STORMWATER AS-BUILT PLANS

SUBMISSION CHECKLIST

GAS HOUSE PIKE WIDENING HAMPTONS WEST

REDLINE RETROFIT STRUCTURAL DETAILS - POND 6B
IMPROVEMENT PLAN
TALLYN RIDGE FINAL ASBUILT POND 6B
TAX MAP 78, GRID 20, PARCEL 742, LOTS 1-4, TAX MAP 78, GRID 19, PARCEL 55, ACCT. # 09317546, # 09317554, # 09317562 & # 09317570
LIBER 9283 AT FOLIO 068
NEW MARKET, ELECTION DISTRICT NO. 9

AS-BUILT

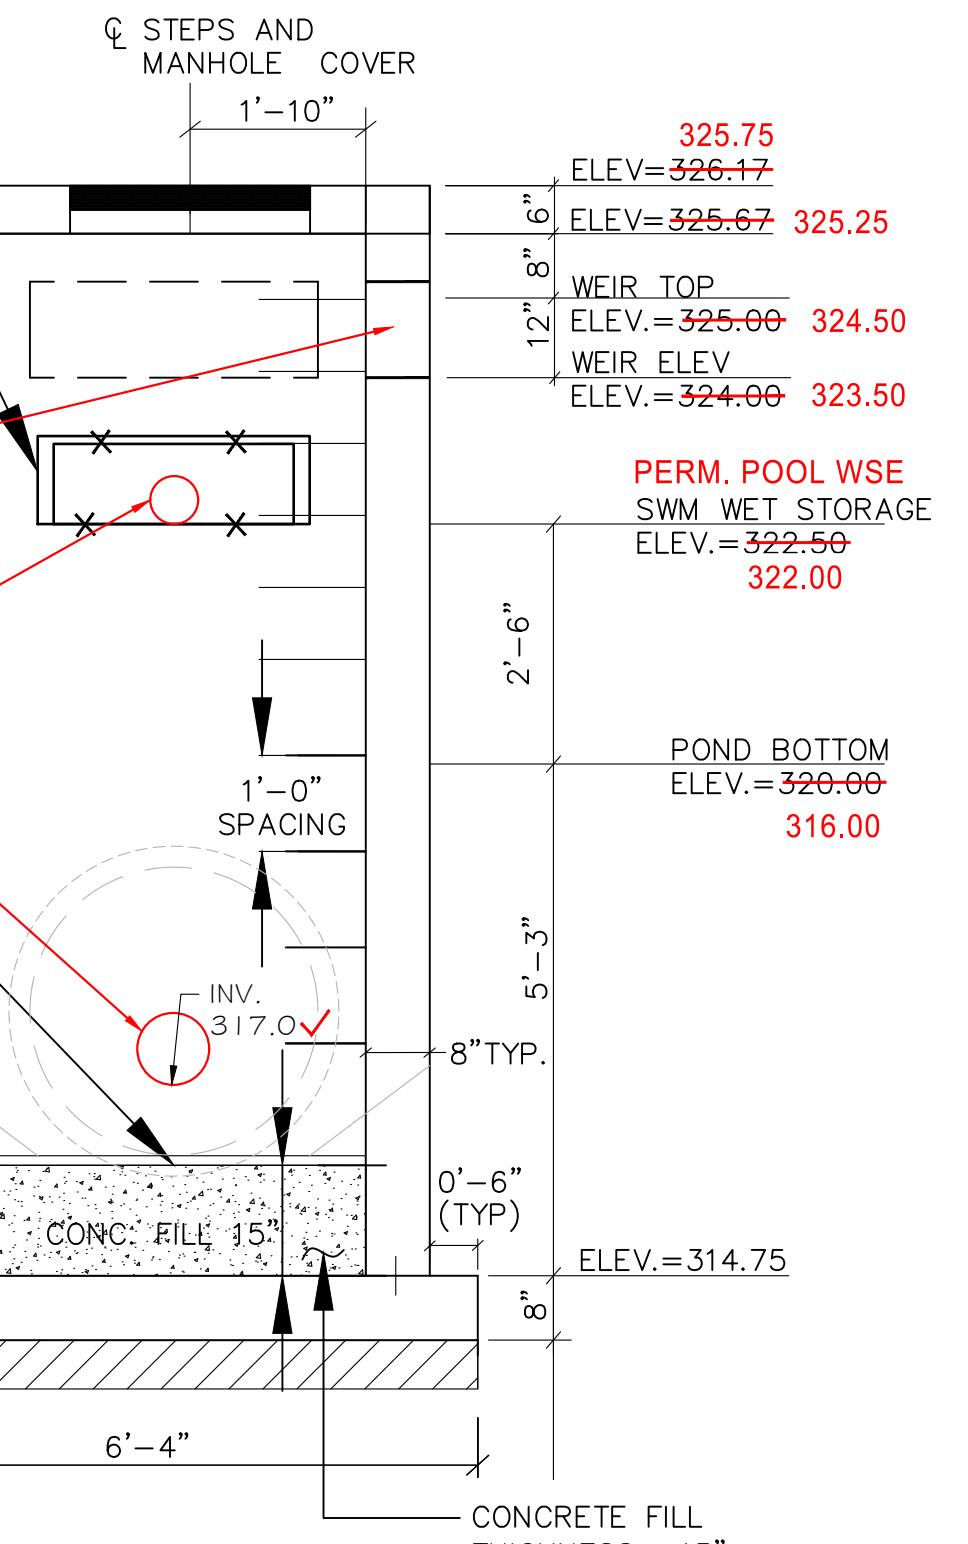
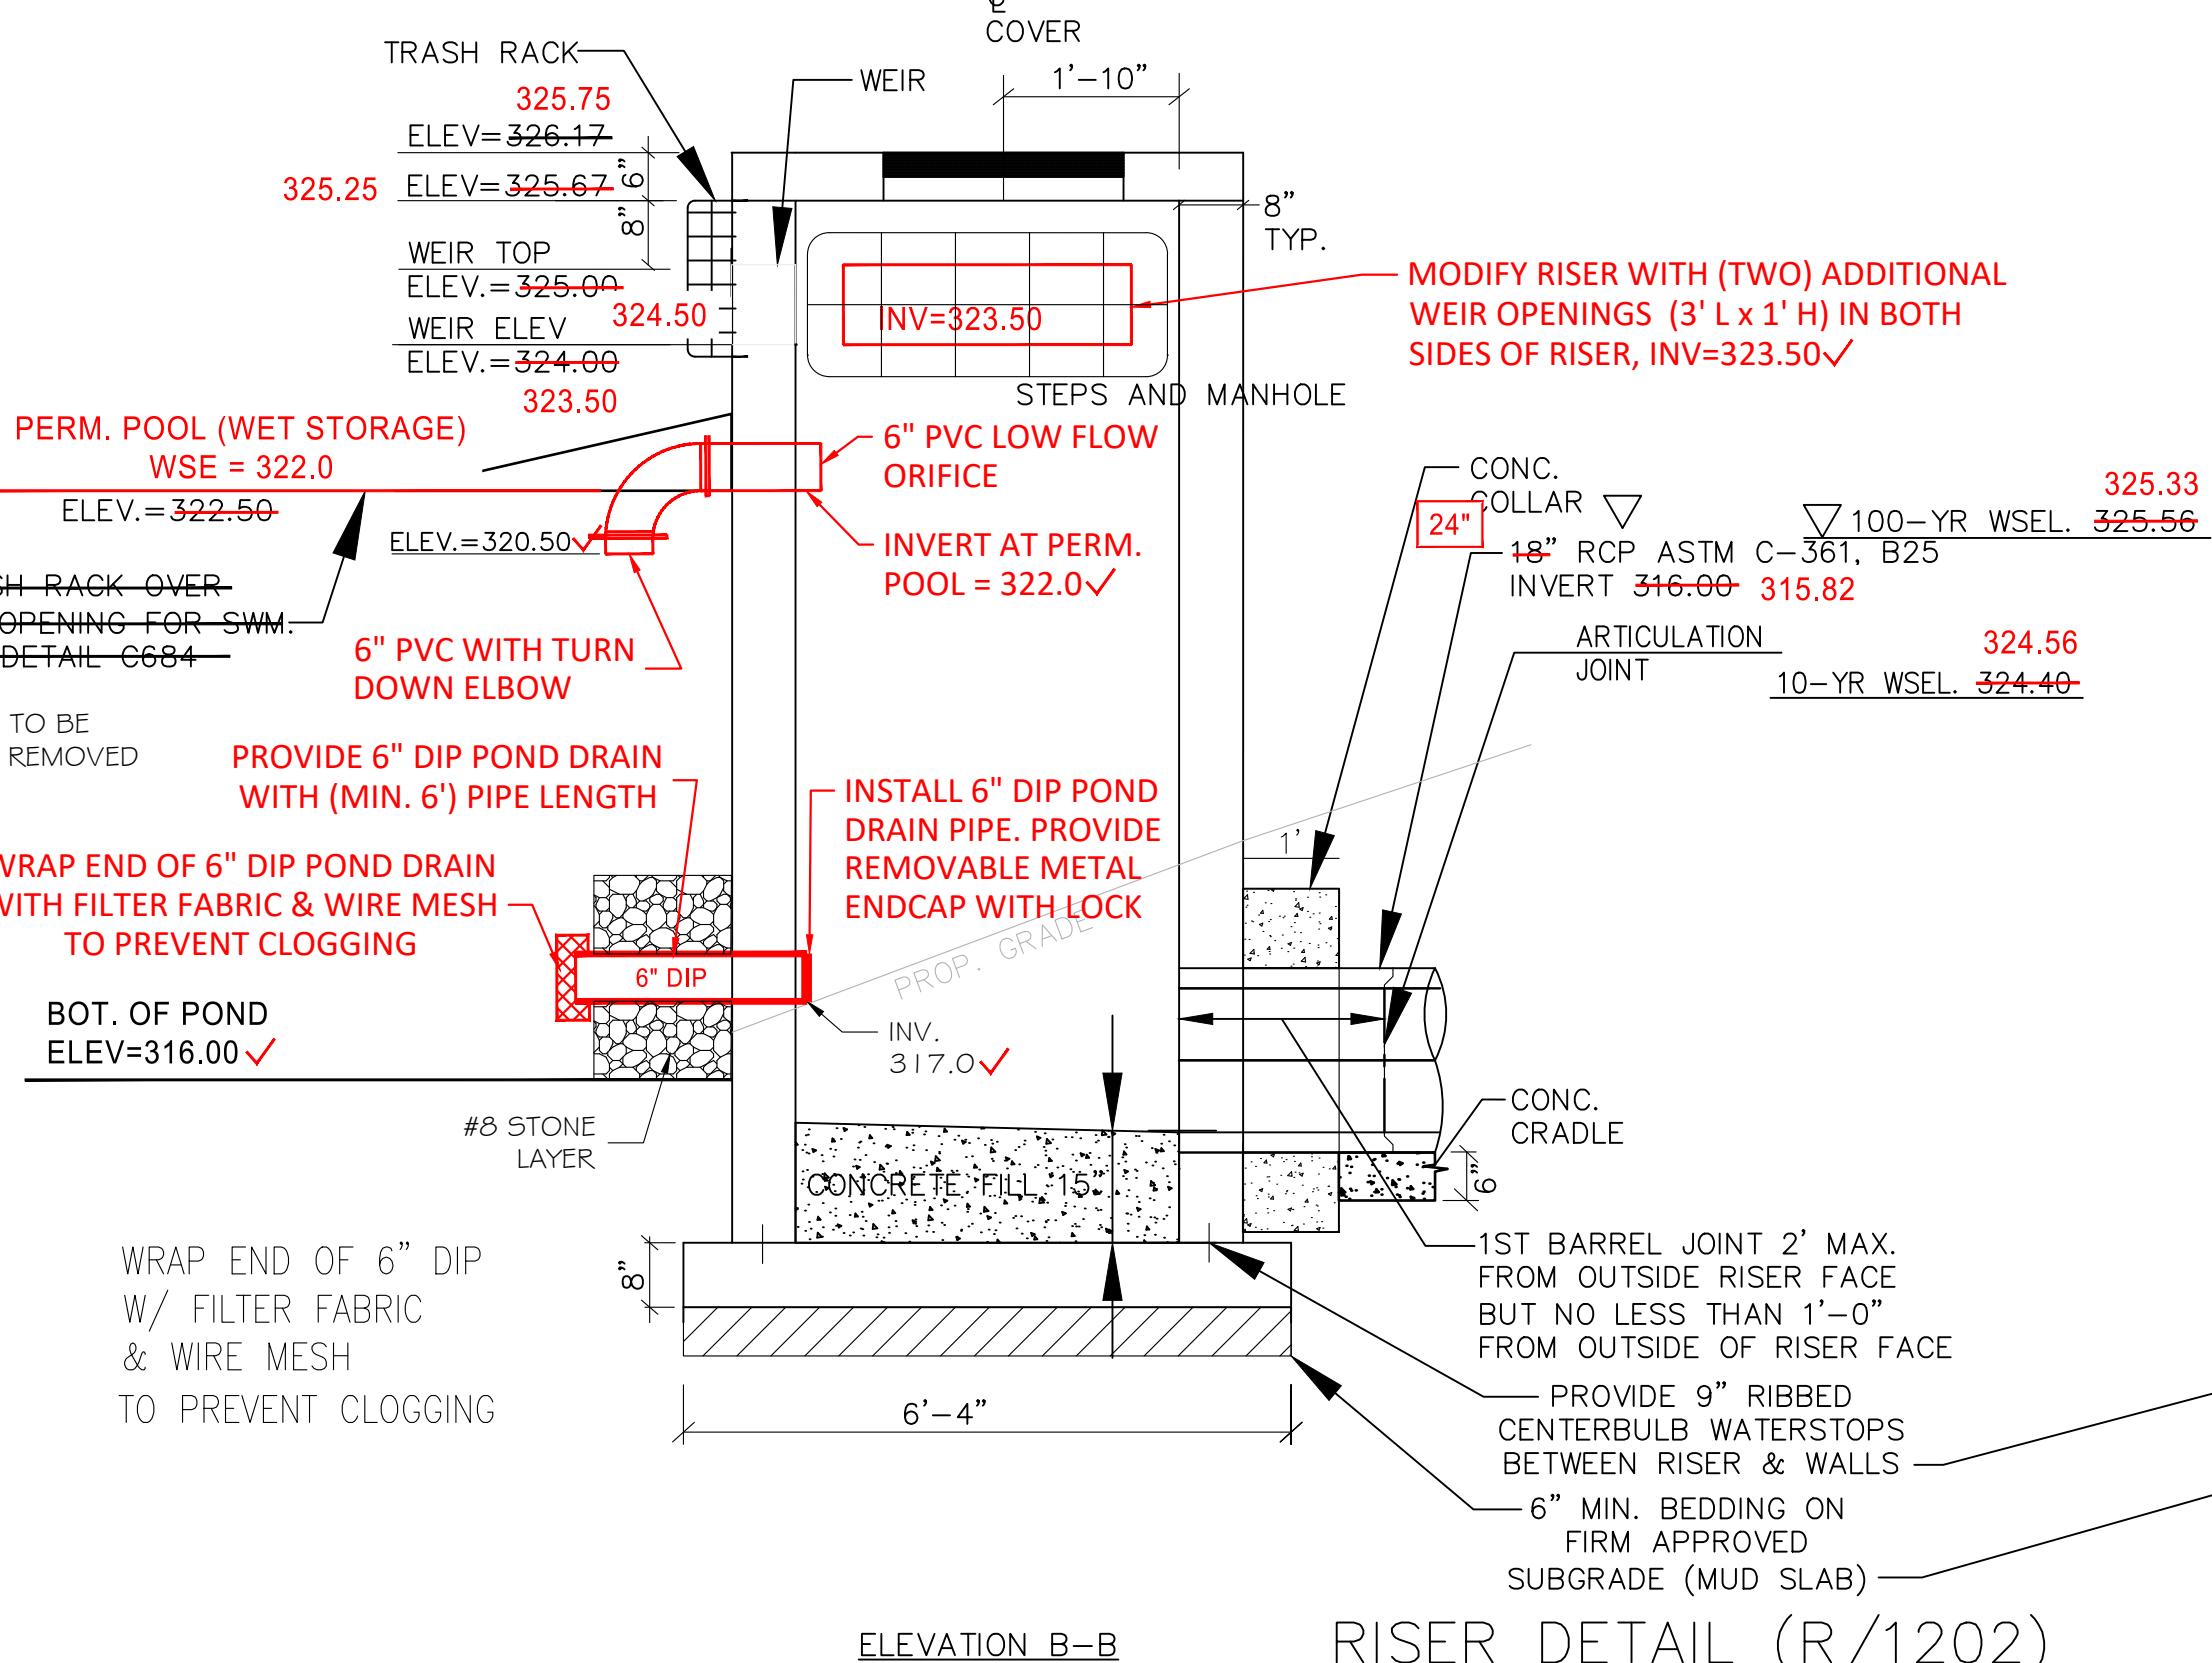
NOTE: TRASH RACK TO BE MODIFIED ADDED (TWO) SIDES

Redlined Details

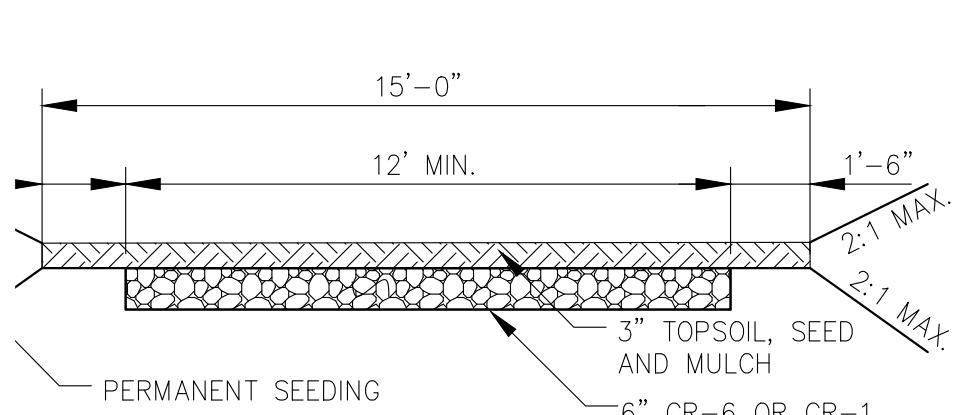
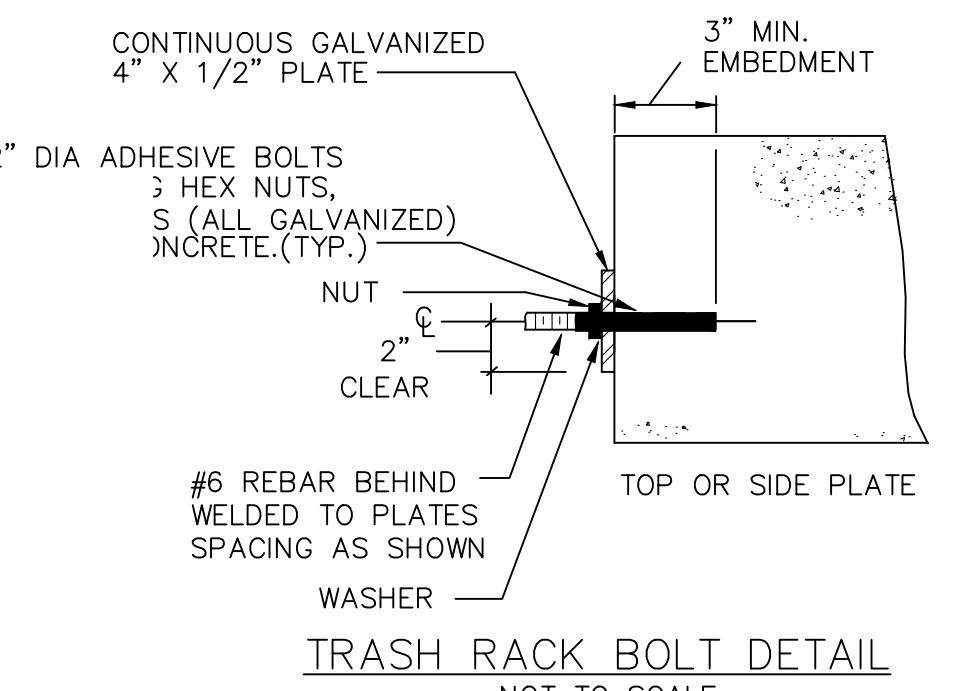
NOTE: SWM POND (6B) TO BE RETROFITTED WITH POND LINER INSTALLATION AND MODIFICATION OF RISER STRUCTURE. SEE SWM POND (6B) IMPROVEMENT PLAN SHT-006 FOR CHANGES.
